Development Review Comments

PAM2024-00151

2101 Gaither Road

PRE-APPLICATION SITE PLAN

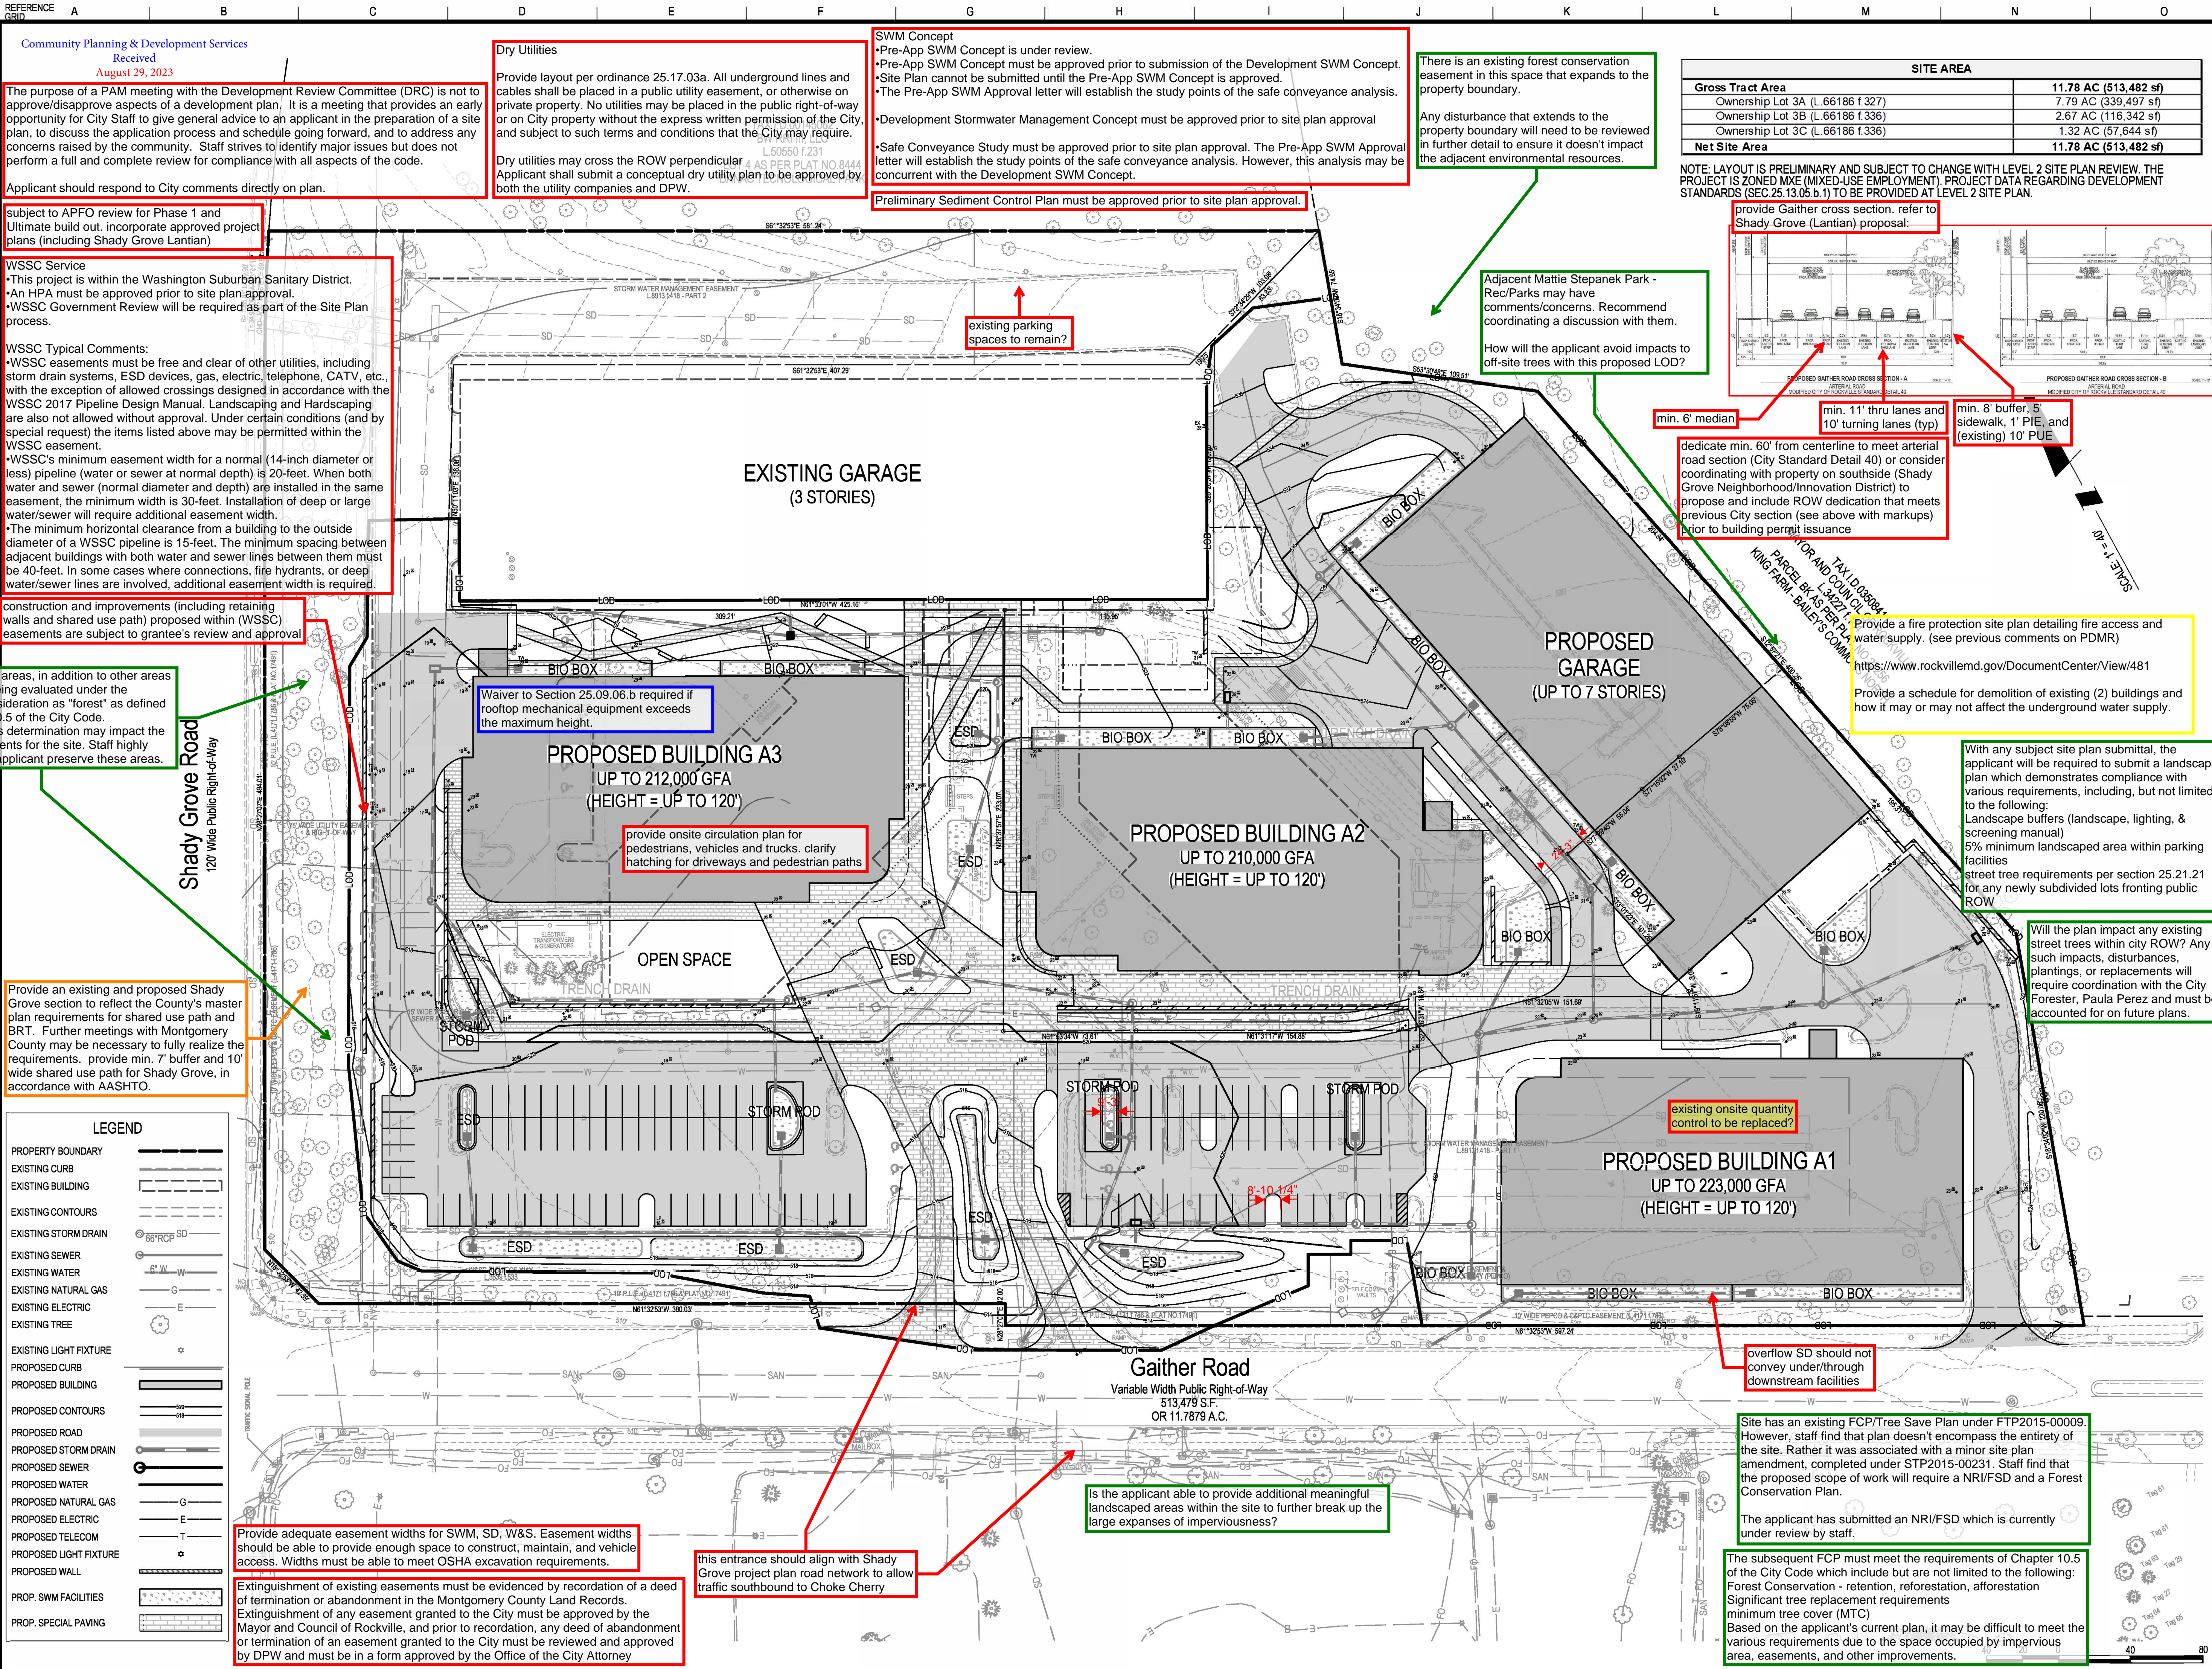
Applicant should respond to City comments directly on plan.

subject to APFO review for Phase 1 and Ultimate build out. incorporate approved project plans (including Shady Grove Lantian)

WSSC Service
•This project is within the Washington Suburban Sanitary District.
•An HPA must be approved prior to site plan approval.
•WSSC Government Review will be required as part of the Site Plan process.

WSSC Typical Comments:
•WSSC easements must be free and clear of other utilities, including storm drain systems, ESD devices, gas, electric, telephone, CATV, etc., with the exception of allowed crossings designed in accordance with the WSSC 2017 Pipeline Design Manual. Landscaping and Hardscaping are also not allowed without approval. Under certain conditions (and by special request) the items listed above may be permitted within the WSSC easement.
•WSSC's minimum easement width for a normal (14-inch diameter or less) pipeline (water or sewer at normal depth) is 20-feet. When both water and sewer (normal diameter and depth) are installed in the same easement, the minimum width is 30-feet. Installation of deep or large water/sewer will require additional easement width.
•The minimum horizontal clearance from a building to the outside diameter of a WSSC pipeline is 15-feet. The minimum spacing between adjacent buildings with both water and sewer lines between them must be 40-feet. In some cases where connections, fire hydrants, or deep water/sewer lines are involved, additional easement width is required.

construction and improvements (including retaining walls and shared use path) proposed within (WSSC) easements are subject to grantee's review and approval

These vegetated areas, in addition to other areas on the site are being evaluated under the NRI/FSD for consideration as "forest" as defined under Chapter 10.5 of the City Code. The results of this determination may impact the forestry requirements for the site. Staff highly recommend the applicant preserve these areas.

Provide an existing and proposed Shady Grove section to reflect the County's master plan requirements for shared use path and BRT. Further meetings with Montgomery County may be necessary to fully realize the requirements. provide min. 7' buffer and 10' wide shared use path for Shady Grove, in accordance with AASHTO.

Dry Utilities
Provide layout per ordinance 25.17.03a. All underground lines and cables shall be placed in a public utility easement, or otherwise on private property. No utilities may be placed in the public right-of-way or on City property without the express written permission of the City, and subject to such terms and conditions that the City may require.
Dry utilities may cross the ROW perpendicular
Applicant shall submit a conceptual dry utility plan to be approved by both the utility companies and DPW.

SWM Concept
•Pre-App SWM Concept is under review.
•Pre-App SWM Concept must be approved prior to submission of the Development SWM Concept.
•Site Plan cannot be submitted until the Pre-App SWM Concept is approved.
•The Pre-App SWM Approval letter will establish the study points of the safe conveyance analysis.
•Development Stormwater Management Concept must be approved prior to site plan approval
•Safe Conveyance Study must be approved prior to site plan approval. The Pre-App SWM Approval letter will establish the study points of the safe conveyance analysis. However, this analysis may be concurrent with the Development SWM Concept.
Preliminary Sediment Control Plan must be approved prior to site plan approval.

There is an existing forest conservation easement in this space that expands to the property boundary.
Any disturbance that extends to the property boundary will need to be reviewed in further detail to ensure it doesn't impact the adjacent environmental resources.

Adjacent Mattie Stepanek Park - Rec/Parks may have comments/concerns. Recommend coordinating a discussion with them.
How will the applicant avoid impacts to off-site trees with this proposed LOD?

min. 6' median
dedicate min. 60' from centerline to meet arterial road section (City Standard Detail 40) or consider coordinating with property on southside (Shady Grove Neighborhood/Innovation District) to propose and include ROW dedication that meets previous City section (see above with markups) prior to building permit issuance
min. 11' thru lanes and 10' turning lanes (typ)
min. 8' buffer, 5' sidewalk, 1' PIE, and (existing) 10' PUE

Provide a fire protection site plan detailing fire access and water supply. (see previous comments on PDMR)
<https://www.rockvillemd.gov/DocumentCenter/View/481>

Provide a schedule for demolition of existing (2) buildings and how it may or may not affect the underground water supply.

With any subject site plan submittal, the applicant will be required to submit a landscape plan which demonstrates compliance with various requirements, including, but not limited to the following:
Landscape buffers (landscape, lighting, & screening manual)
5% minimum landscaped area within parking facilities
street tree requirements per section 25.21.21 for any newly subdivided lots fronting public ROW

Will the plan impact any existing street trees within city ROW? Any such impacts, disturbances, plantings, or replacements will require coordination with the City Forester, Paula Perez and must be accounted for on future plans.

Provide adequate easement widths for SWM, SD, W&S. Easement widths should be able to provide enough space to construct, maintain, and vehicle access. Widths must be able to meet OSHA excavation requirements.
Extinguishment of existing easements must be evidenced by recordation of a deed of termination or abandonment in the Montgomery County Land Records. Extinguishment of any easement granted to the City must be approved by the Mayor and Council of Rockville, and prior to recordation, any deed of abandonment or termination of an easement granted to the City must be reviewed and approved by DPW and must be in a form approved by the Office of the City Attorney

this entrance should align with Shady Grove project plan road network to allow traffic southbound to Choke Cherry

Is the applicant able to provide additional meaningful landscaped areas within the site to further break up the large expanses of imperviousness?

Site has an existing FCP/Tree Save Plan under FTP2015-00009. However, staff find that plan doesn't encompass the entirety of the site. Rather it was associated with a minor site plan amendment, completed under STP2015-00231. Staff find that the proposed scope of work will require a NRI/FSD and a Forest Conservation Plan.
The applicant has submitted an NRI/FSD which is currently under review by staff.

The subsequent FCP must meet the requirements of Chapter 10.5 of the City Code which include but are not limited to the following:
Forest Conservation - retention, reforestation, afforestation
Significant tree replacement requirements
minimum tree cover (MTC)
Based on the applicant's current plan, it may be difficult to meet the various requirements due to the space occupied by impervious area, easements, and other improvements.

Table 1
2102 Gaither Road
Site Trip Generation (1)

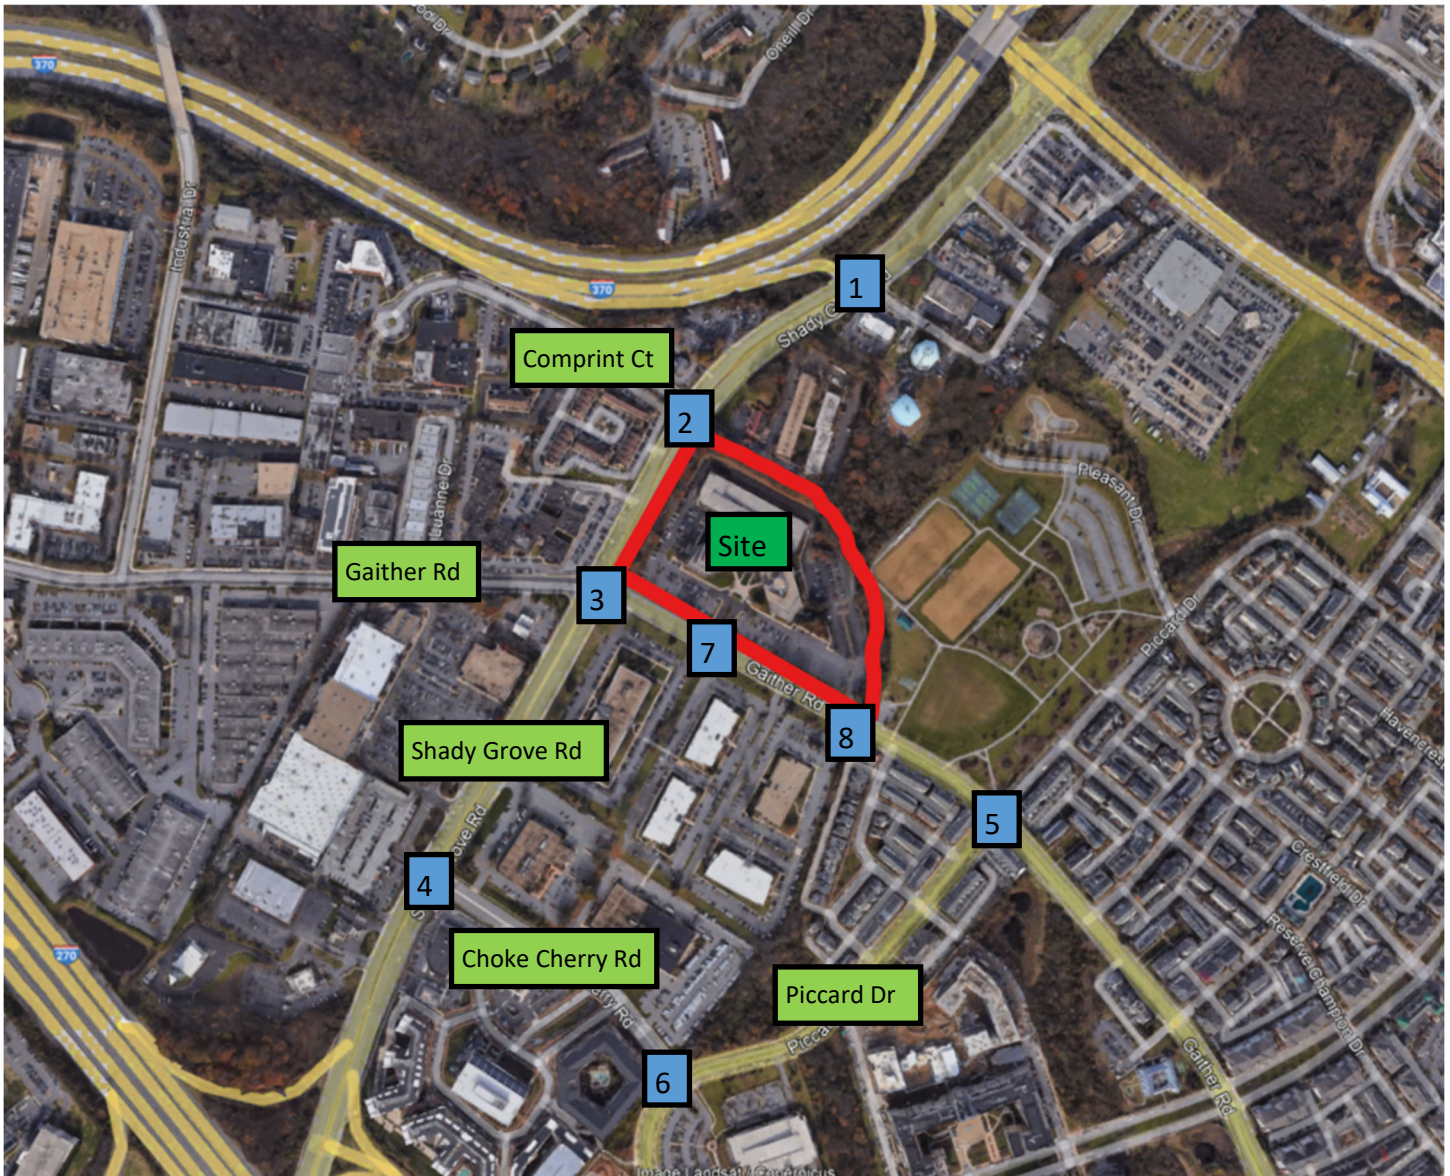
Please provide detailed trip calculations for phase 1, which include the existing 260, 000 SF of office and the amount of proposed new R&D development that will be constructed with Phase 1, and any other development phase as well as for the ultimate buildout.

Complete and detailed analysis needed for each phase as well as the build out condition. For the background all prior approved development applications that are not fully occupied with the study area (min. radius of 0.35 miles) must be included. For each phase and build out the assumed transportation network may include all programmed with 100% funded for construction improvements as well as any improvements required of already approved developments. This also means the T&T recommended approval conditions for the proposed plan would call for provision of the same improvements.

As required by the CTR and in addition to a revised scoping intake form, please submit for review a detailed technical approach and methodology report and include detailed trip distribution (% and trips) for each phase and for each background development that are based on the patterns included in the approved transportation study or are determined using the most recent M-NCPPC regional trip tables. please make sure to show the needed information using maps and figures that include all identified intersections within the study area. Please also note, the required CTR review fee based on the number of intersections identified in this draft scoping form, is \$7000.

As required by CTR, staff recommends Sat peak hour analysis for for all identified intersections in addition to weekday AM and PM peak hours. staff also recommend as required special studies, submittal of detailed peak hour queue analysis for the existing, and projected left turning traffic volumes from Gaither Road to shady Grove and full traffic signal warrant study for the intersection of Gaither Road and the site's north site access road.
